California Air Resources Board

**Public Hearing to Consider Proposed  
Amendments to the Greenhouse Gas  
Emission Standards for Crude Oil and  
Natural Gas Facilities**

**Final Statement of Reasons for Rulemaking,  
Including Summary of Comments and  
Agency Response**

*Public Hearing Date: June 22, 2023  
Agenda Item No.: 23-6-2.*

Figure 1. Partial applicability scenario of COGR to separator and tank systems due to Rule 4623 applicability

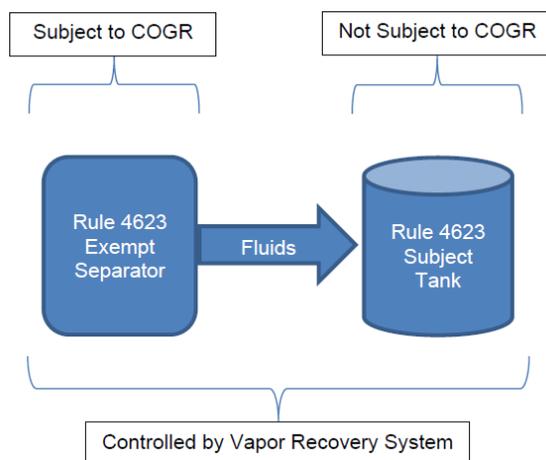
Specifying SIP-approved Rule 4623 has also resulted in partial applicability of COGR to separator and tank systems with existing vapor control, as separators are exempt from Rule 4623, unlike tanks. Separators can be pressure vessels that are capable of maintaining working pressures sufficient to prevent losses to the atmosphere at all times (Rule 4623, Section 3.24). Pressure vessels are exempt from Rule 4623 per Section 4.1.1, making them subject to COGR. However, these separators direct fluids to tanks that are subject to Rule 4623 and both the separator and tank are under vapor control that meet the requirements of Rule 4623. Please see Figure 1 below.

WSPA members understand that it was not CARB’s intent to create a partial applicability scenario. As such, WSPA requests that CARB include exemptions for existing vapor-controlled separators that direct fluids to tanks that are subject to Rule 4623.

WSPA recommends that CARB add the following exemption to Section 95668(a)(2) for vapor-controlled separators that direct fluids to tanks that are subject to Rule 4623 (also included in Appendix A):

No changes were made in response to these comments. U.S. EPA's SIP Decision specified in Deficiency 1 that subsections 95668(a)(2)(C), 95669(b)(1), and 95670(a)(1) include insufficiently specific exemptions for storage tanks or components "approved for use by a local air district" or "subject to a local air district requirement." Through subsequent discussion with U.S. EPA, staff determined that for SIP approval reasons U.S. EPA would not view permit requirements resulting from non-prohibitory rules as an acceptable basis for exemption. U.S. EPA does not view such conditions as sufficiently enduring, are not able to assess the stringency of those conditions, and are unable to enforce those permits through the Clean Air Act because specific permit conditions are not in the SIP. Although some exemptions may be lost through the Proposed Amendments, there is no viable alternative to maintain exemptions for vapor collection systems (VCS) installed pursuant to non-prohibitory rules that would meet U.S. EPA's requirements for SIP approval. Therefore, in order to achieve SIP approval, VCS installed as a result of a Best Available Control Technology (BACT) assessment (such as under SJVAPCD Rule 2201), but not mandated by a prohibitory rule, cannot be used as an exemption for the requirements of the Proposed Amendments.

Figure 1. Partial applicability scenario of COGR to separator and tank systems due to Rule 4623 applicability

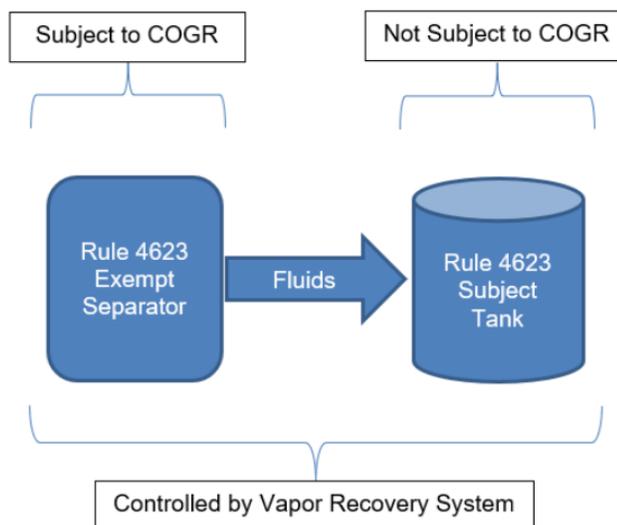
In the previous comment letters dated [February 10, 2023](#) and [June 12, 2023](#), WSPA had pointed out that by specifying SIP-approved Rule 4623 an issue of partial applicability to COGR was created for separator and tank systems with existing vapor control. Separators are exempt from Rule 4623 per Section 4.1.1, making them subject to COGR. However, the separators direct fluids to tanks that are subject to Rule 4623 and both the separator and tank are under vapor control that meet the requirements of Rule 4623. Please see Figure 1 below.

WSPA members had requested CARB to include an exemption to Section 95668(a)(2) for existing vapor-controlled separators that direct fluids to tanks that are subject to Rule 4623 as it was not CARB's intent to create a partial applicability scenario. However, the previously provided comments were not addressed in the November 2, 2023 version.
